SUBJECT: Corrected ltr forwarding revised changes to FSAR Chapter 13.

Arizona Public Service Company

Subject: Palo Verde Nuclear Generating Station (PVNGS)
Units 1, 2, and 3
Revised Changes to Chapter 13 of the FSAR
Docket Nos STN 50-528/529/530
File: 84-056-026; G.1.01.10

APS MASTER ORGANIZATION
 Figure 13.1-1

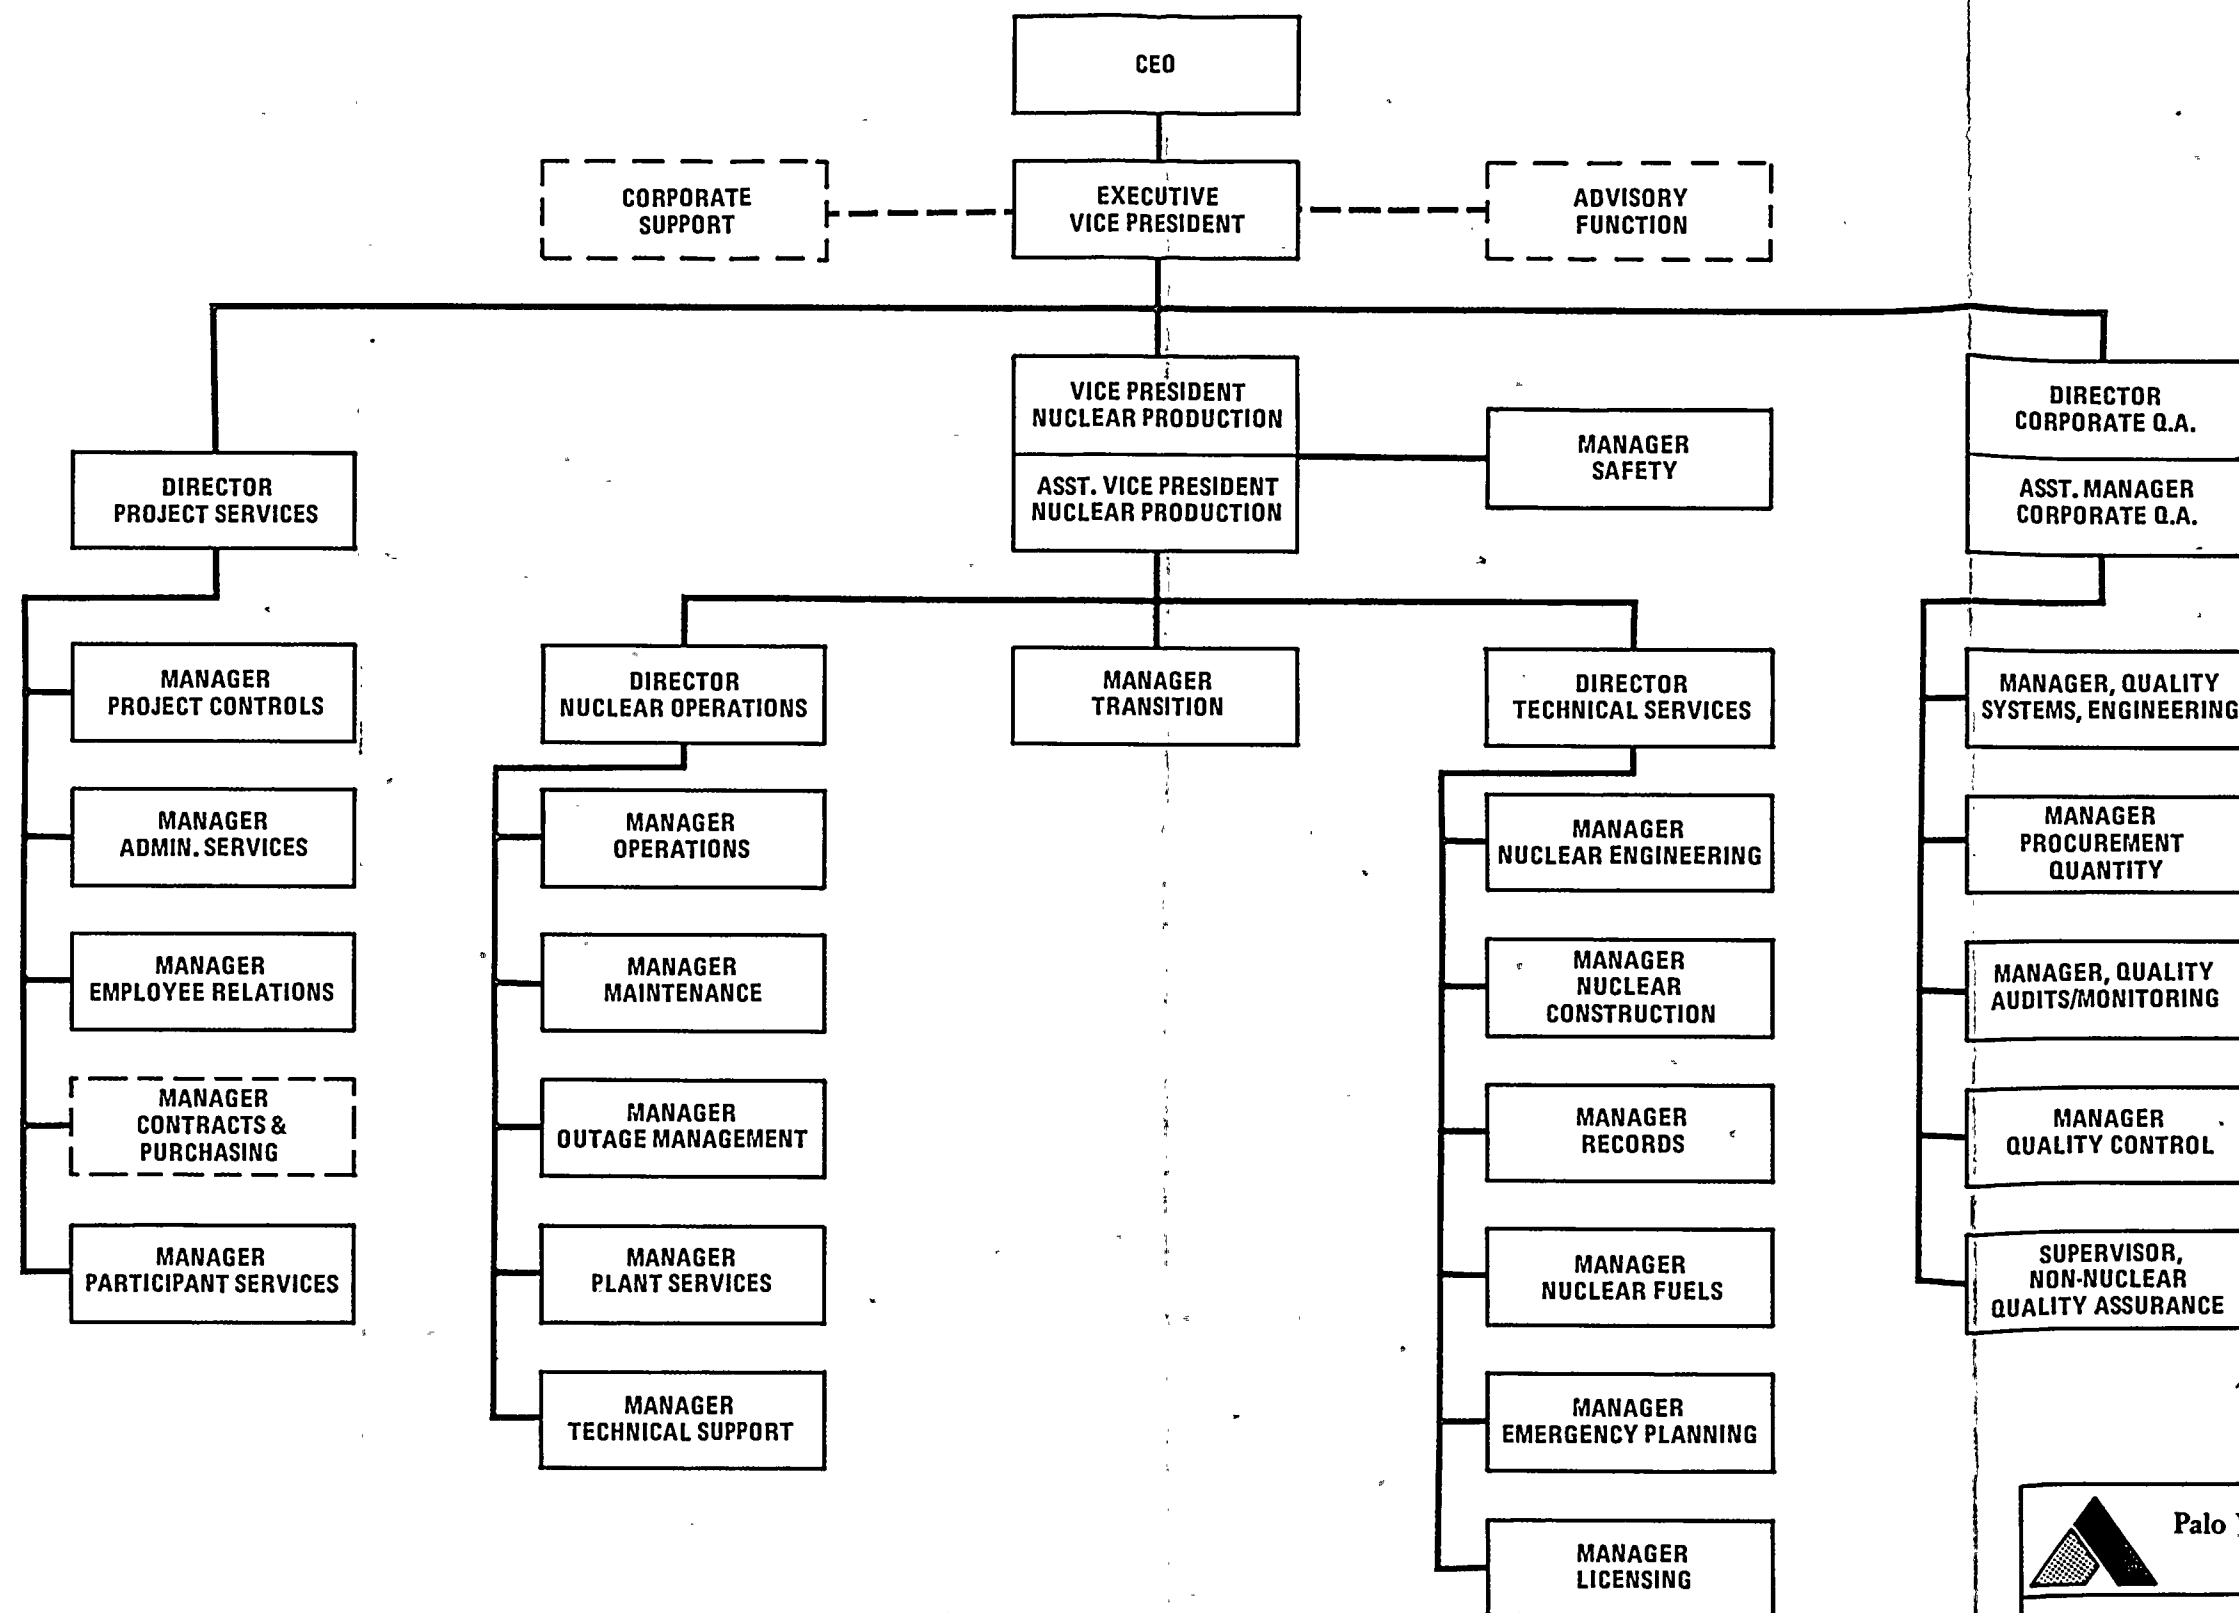
Attached are revised changes to Chapter 13 of the FSAR. Revised Figures 13.1-1, 13.1-2, 13.1-3, and changes to pages in the text are to replace the respective pages currently in the FSAR.
